NORTHEAST UTILITIES

Millstone Nuclear Power Station, Unit No. 3
ATWS Rule--Plant-Specific Information
ATWS Mitigation System Actuation Circuitry (AMSAC) Design

PLANT-SPECIFIC DETAILS REGARDING
ATWS MITIGATION SYSTEM ACTUATION CIRCUITRY (AMSAC)
FOR MILLSTONE UNIT NO. 3

FIGURE 1 - COIL TO CONTACT INDUCED VOLTAGE

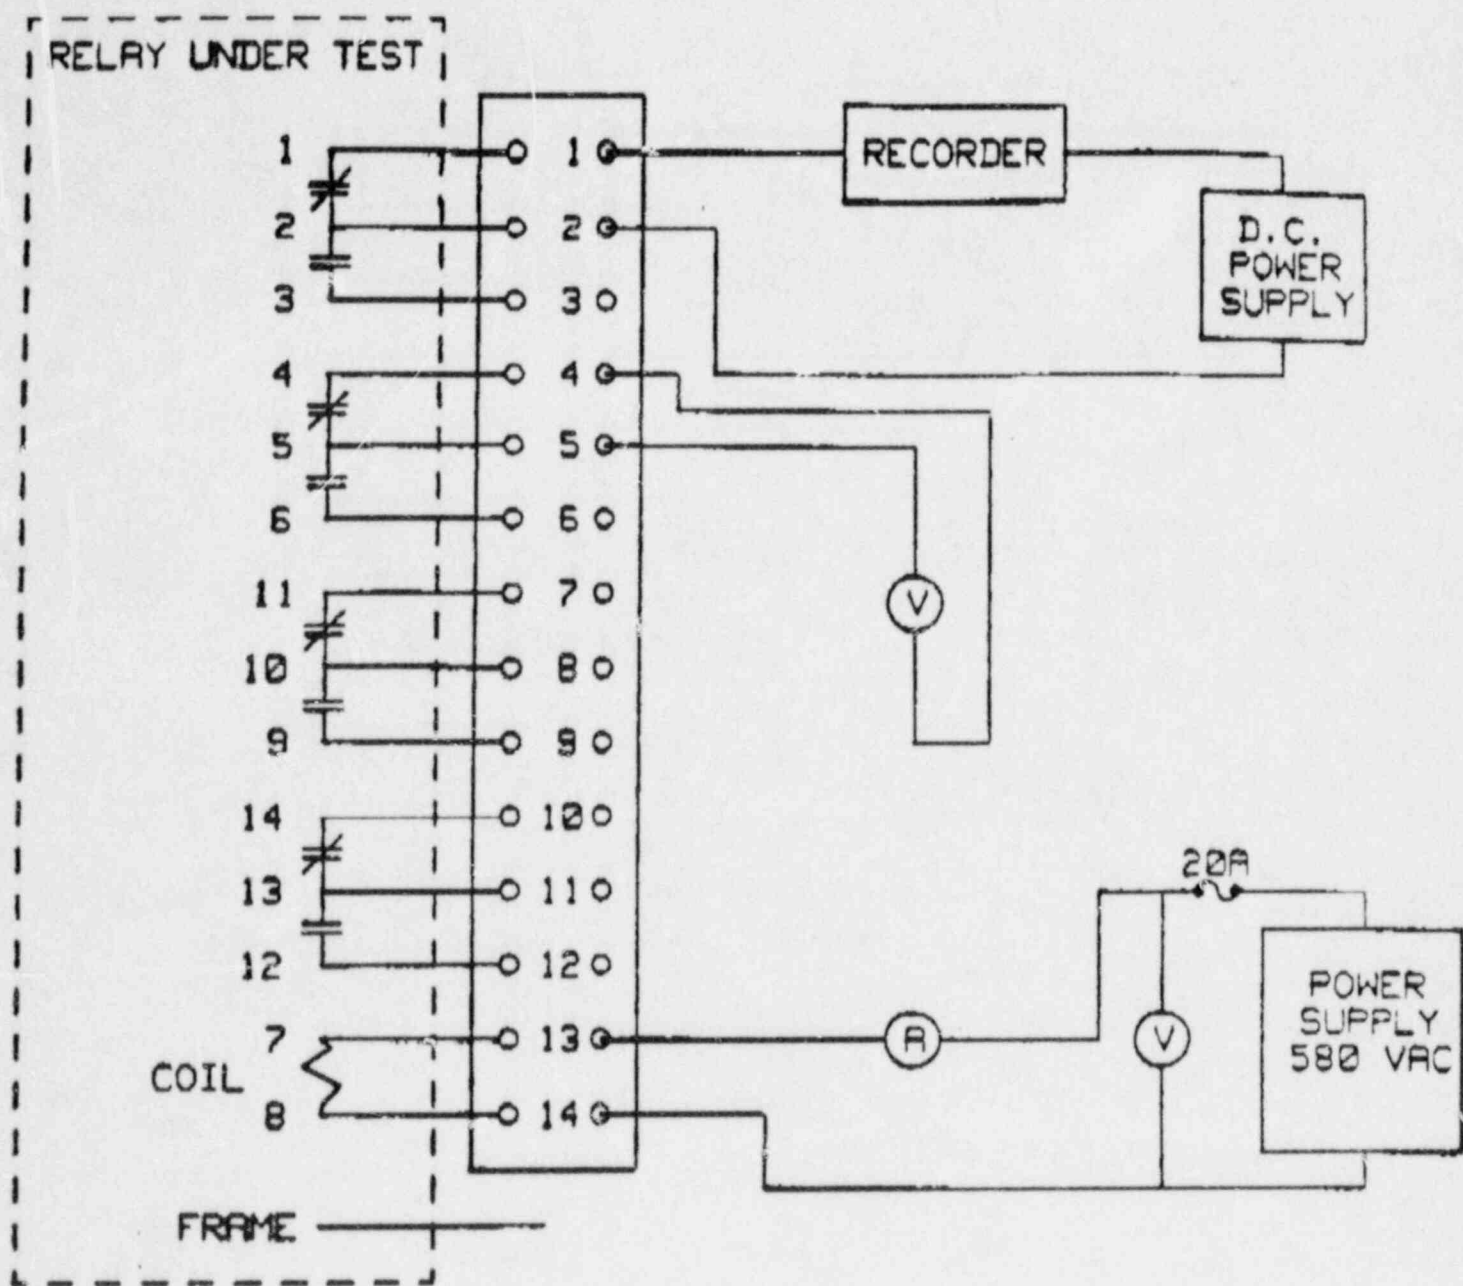
Test 7

- o 590 VAC across the coil.

For this test (Figure 1), the relays had been tested with the maximum credible fault (MCF) of 590 VAC applied to the relay coil in the transverse mode. A normally closed contact was connected to a strip chart to determine the duration of the relay actuation (if any) during application of a fault to the relay coil and to measure the resulting induced voltage on the contact. A second normally closed contact was connected to a DVM to measure induced voltage on the contact for tests on relays 2 and 3. The fault voltage and induced voltage were measured and recorded as listed above.

For each of the relay test cases, the fault current passed through the relay coils was in the range of 0.38 to 1.08 amperes and was limited by the coil impedance itself.

The relays clearly demonstrated their isolation capability by limiting any propagation of the faulted conditions from the non-Class 1E coil to the Class 1E contacts to a negligible value. This induced contact voltage (maximum of 1.4 volts) was not large enough to cause damage to components typically found in plant protection circuits which AMSAC will be connected. Based upon the performed tests, the Struthers-Dunn relay was demonstrated to be an effective isolation device for the output circuits of AMSAC.
